12 December 2016

**RE: DRAFT MEDIUM DENSITY HOUSING CODE & DESIGN GUIDE IN SEPP
(EXEMPT AND COMPLYING DEVELOPMENT CODES), 2008**

**RE: EXPANDING COMPLYING DEVELOPMENT TO INCLUDE TWO STOREY
MEDIUM DENSITY HOUSING TYPES**

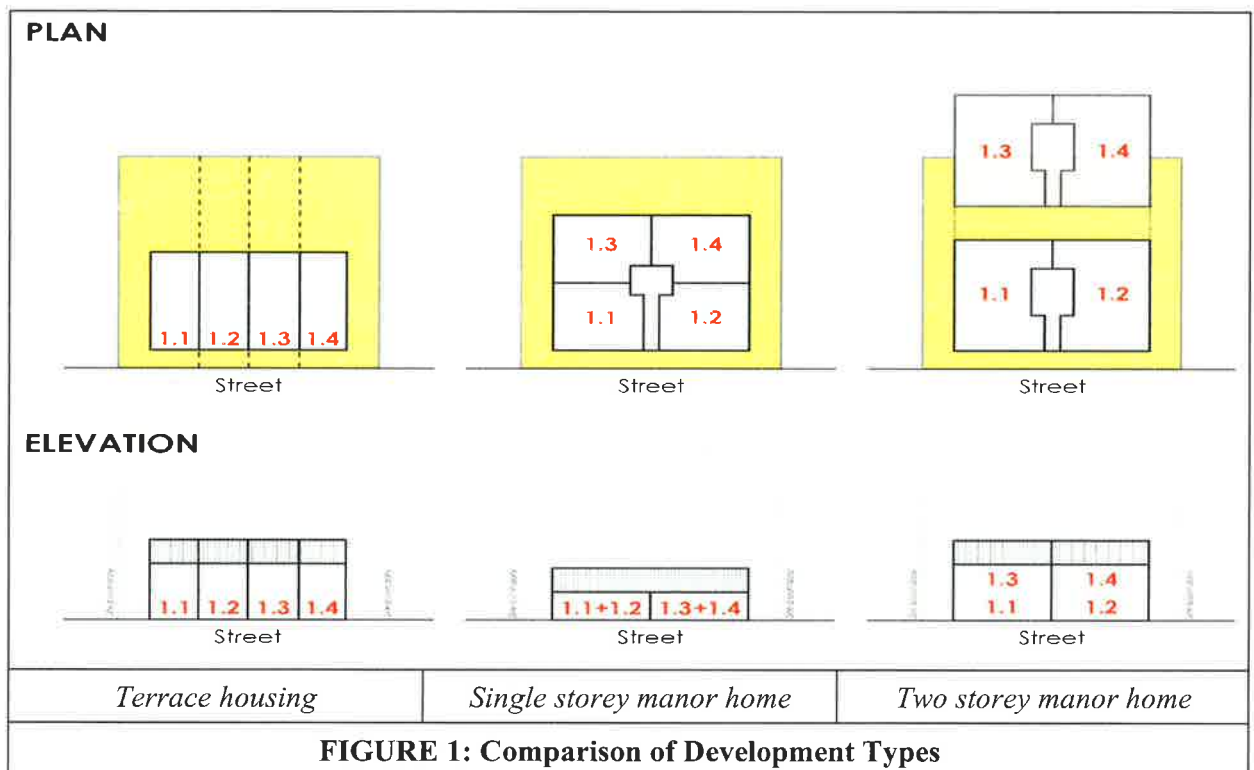
However, the proposed definition of a manor house could technically permit three or four dwellings to be constructed at the ground level. As there are no specific controls proposed requiring a manor house to comprise a two storey built form, there is some confusion as to what could be permitted (refer to Figure 1).

Accordingly, further clarification is required to determine if a manor house can comprise four dwellings in a single storey form.

The new Code should provide clarification as to whether manor houses can comprise four dwellings in a single storey form.
